Revision	Date	Description	Initial	Checked
1	04/03/19	ISSUED FOR DA MODIFICATION	BS	DOMA

42 Honeysuckle Drive, Newcastle
General Arrangement Plan
Ground Floor

Status	SKETCH		
Scale	1 : 150	@	A1
Drawn	BS	Checked	DOMA
Project No.	s12109		
Plot Date	5/03/2019 3:17:23 PM		
Plot File	42HONEYUCKLEDRIVE_ARCH		
Drawing no.	SK.03.101	Revision	1

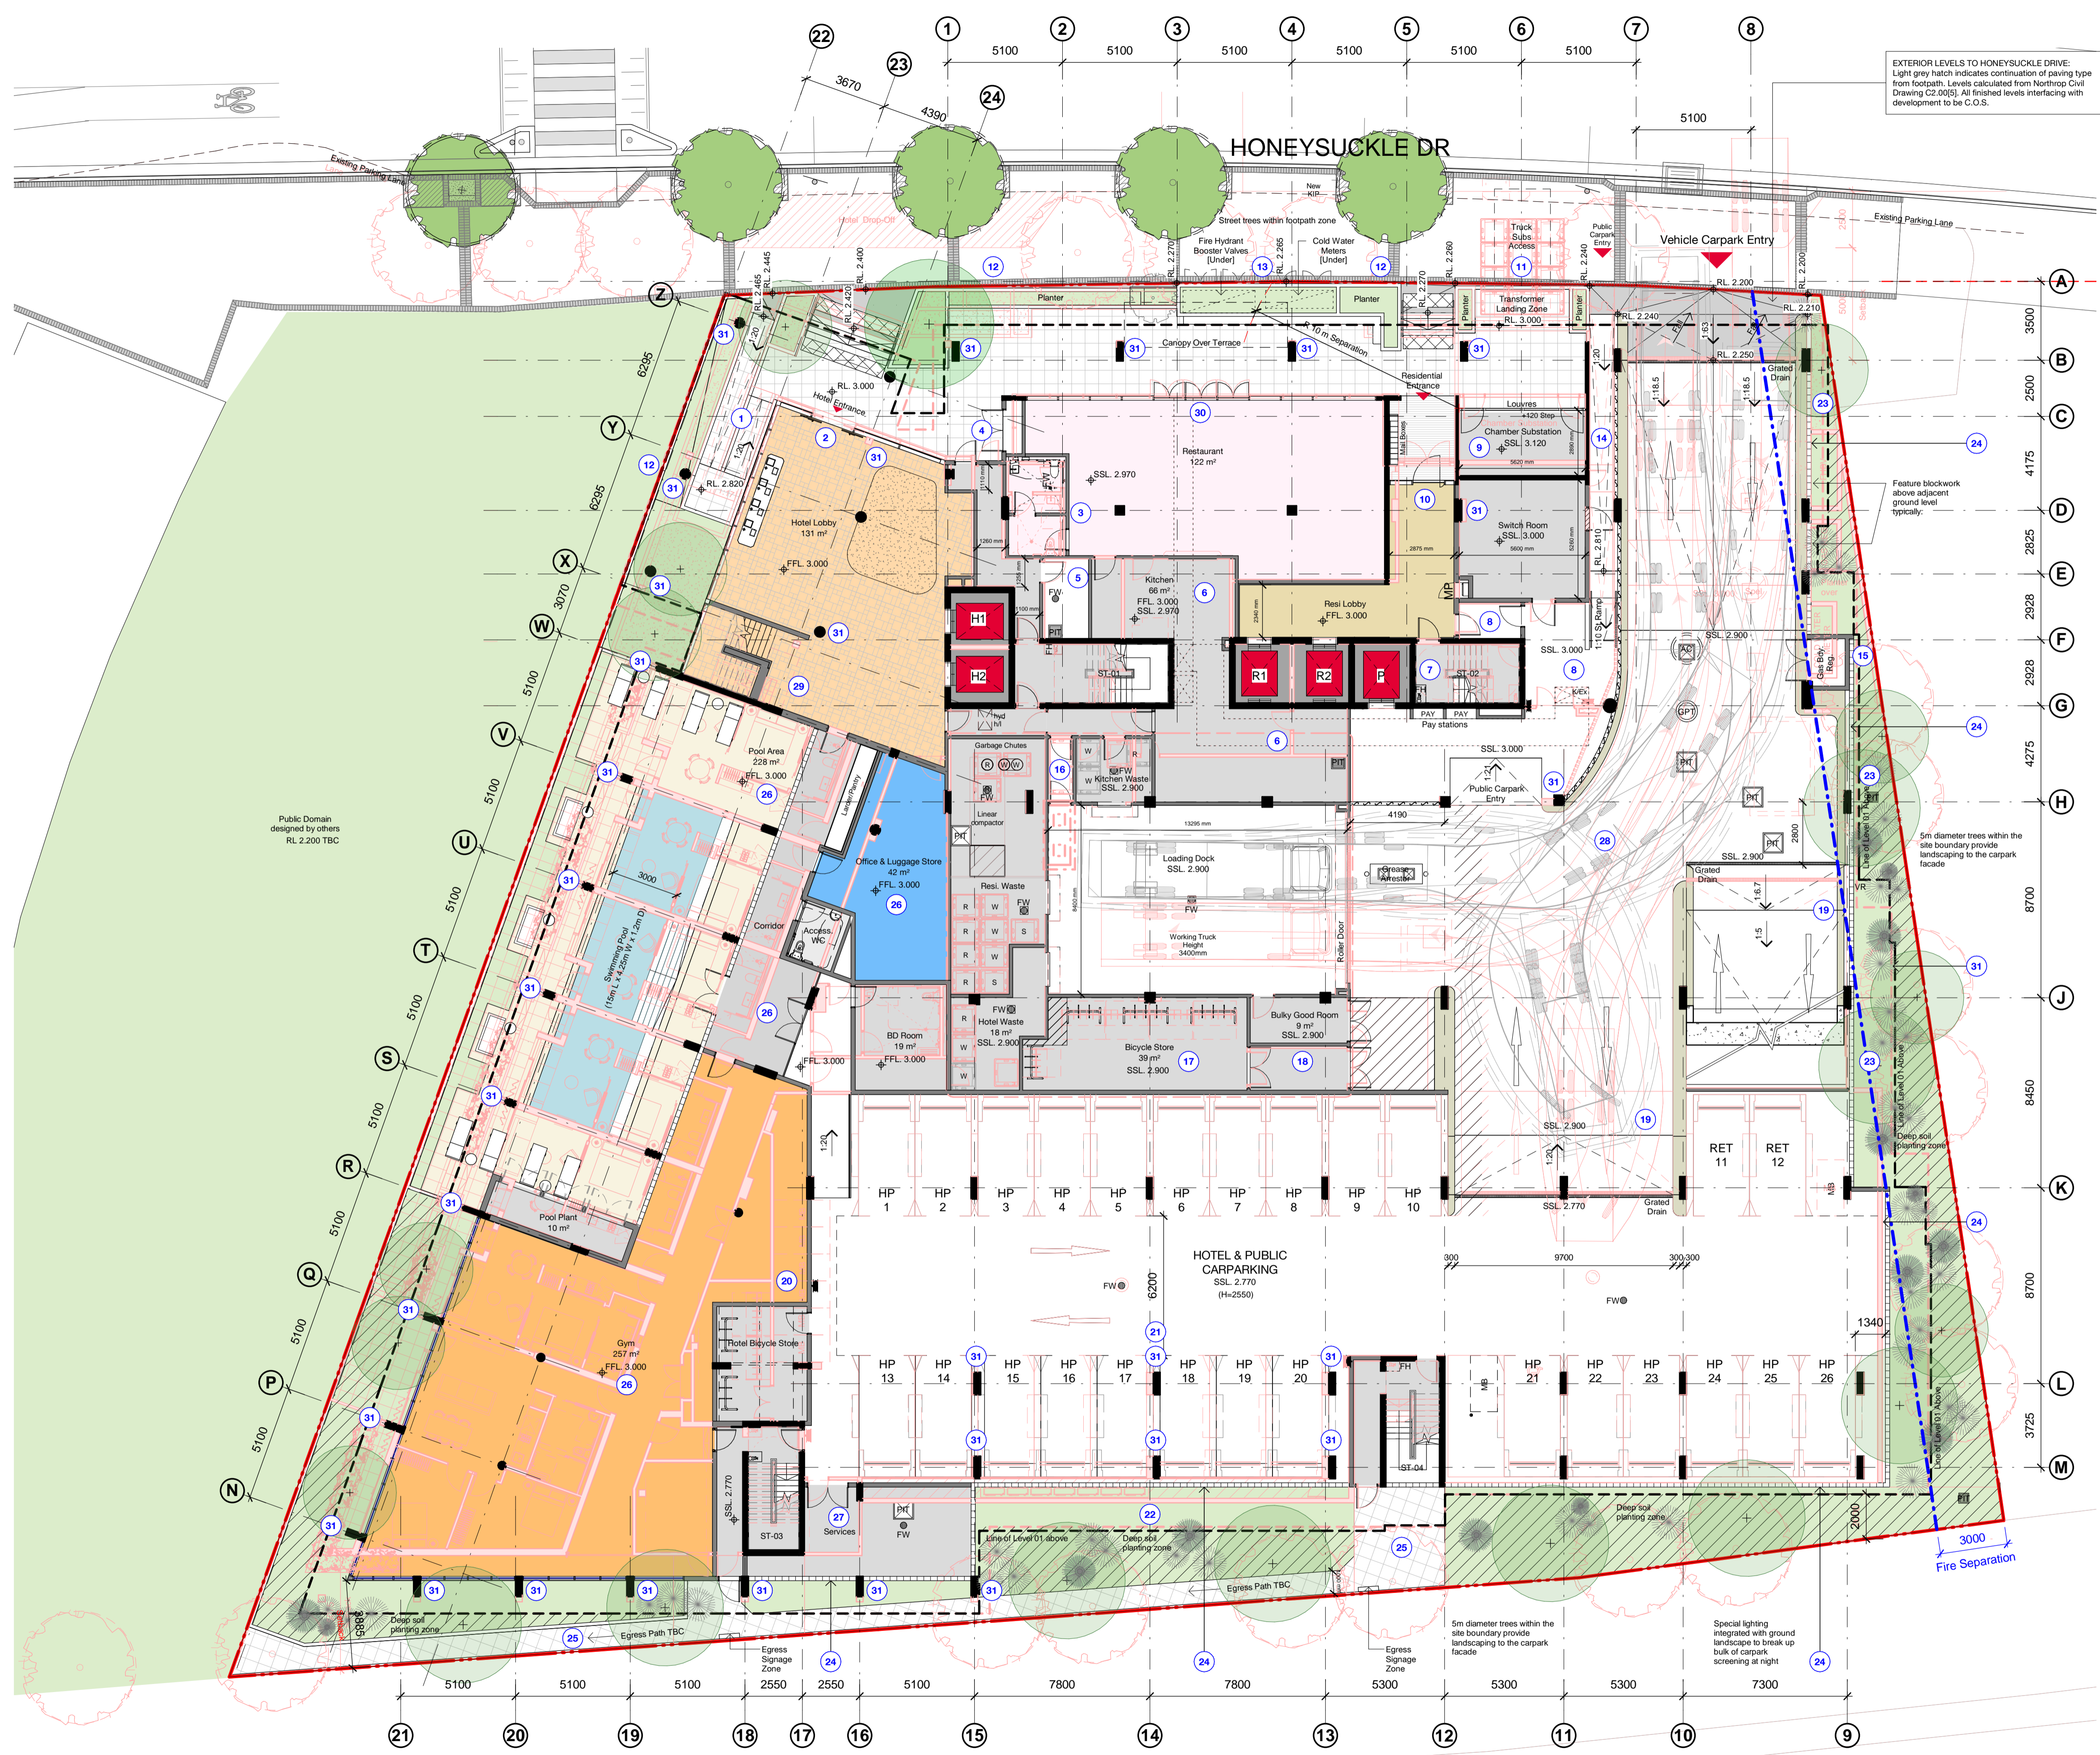
- Ground Floor**
- Hotel entry ramp adjusted to suit more gentle slope.
 - Hotel entry glazing line setback and egress entry moved over.
 - Restaurant WC and vestibule mirrored.

- Fire Brigade Panel cupboard located at NW corner of restaurant in lieu of Fire Control Room.
 - Sprinkler Control Valves located to north of Stair ST-01.

- Store rooms deleted. Restaurant Kitchen extends modified.
 - Stair ST-02 flipped. Egress direct to Resi. Lobby.
 - Public Entry Lobby east of Stair ST-02 modified.

- Chamber Substation moved south. East wall extended north.
 - Resi. Lobby - Entry setback and corridor widened.
 - Transformer Landing Zone modified. Bin setdown deleted.

- Planter box arrangement modified along Honeysuckle Drive.
 - FHBV and Cold Water Meters relocated to Honeysuckle Drive.
 - Pedestrian access ramp layout modified.

- Gas Boundary Regulator moved.
 - Airlock added between Compactor Room and Kitchen Waste Room.
 - Bicycle Store - Rack layout updated.
 - Bulky Good Room extent modified.

- Carpark ramp extends modified.
 - 5 x Motorbike parks deleted. 1 x MB moved east of Stair ST-04.
 - 6 x Hotel Parking spaces moved east.
 - Condenser zone between grids 13-16 (South carpark) relocated.

- Facade modified to suit.
 - Eastern facade extends between East and South facade. Feature blockwork in lieu of concrete walls.
 - Egress path from Stairs ST-03 and ST-04 modified.

- 7 x Serviced Apartments deleted between Grid N-W. Replaced with Swimming Pool and Gymnasium. Structure, landscaping, circulation arrangement, wet areas and office space modified to suit.

- Services room modified between grid 15-18 (South carpark).
 - Portion of carpark between grid E-K lowered to SSL 2,900. Ramps affected modified to suit.

- Common Area Stair between grids W-X widened.
 - Restaurant glazing line setback.
 - Column moved/modified.
